# IEEE802.3bt PSE Rsense Noise Margin

J. Heath – Linear Technology

## Goal of this Presentation

Single-PSE power channel solution

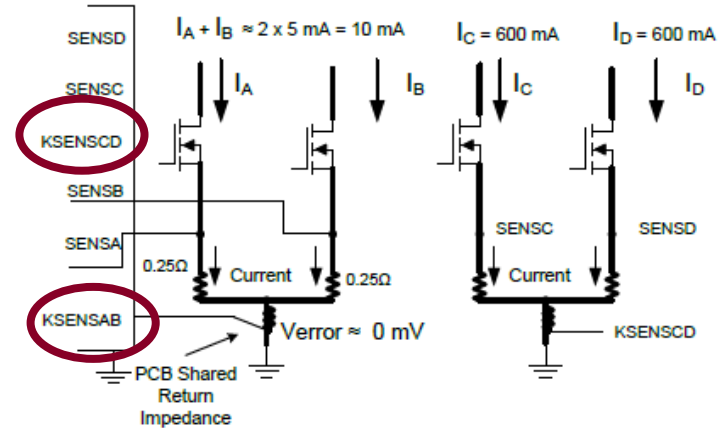
The slide indicates that there is zero common mode error with 2xN architectures and 0.625mV of error with an equivalent 1xN architecture

- The problem with this conclusion is the common resistance assumptions are incorrect

- Example if **1-power channel** solution:  $0.125 \text{ ohm} \times 10\text{mA} = 1.25 \text{ mV}$ . If the "victim" port shares same return impedance with **one** 1.2A aggressor port, only 0.52 mohm can result in **+ 0.625mV error**

# This is an apples to apples comparison

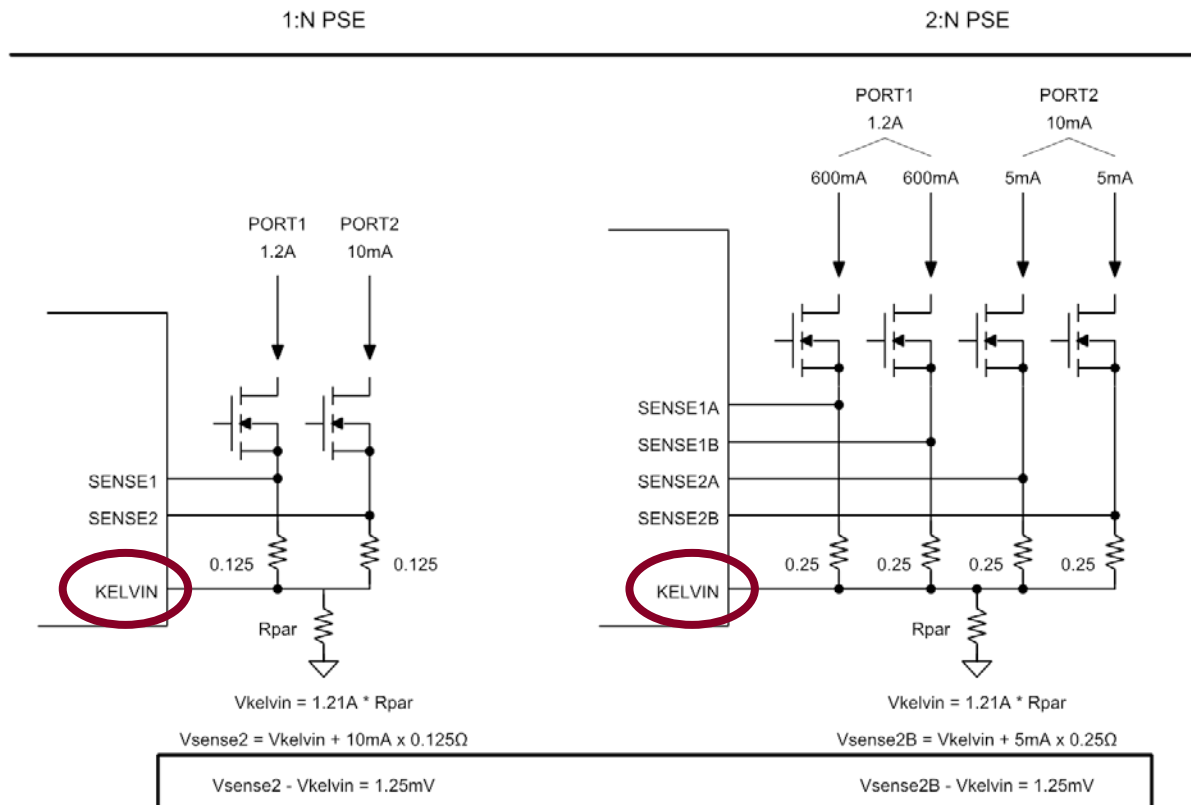
- Here is the math using the same number of Kelvin Connections

- There is no difference in the difficulty measuring DC Disconnect between 2xN and 1xN PSE topologies due to equal common resistance and the same number of Kelvin connections per channel
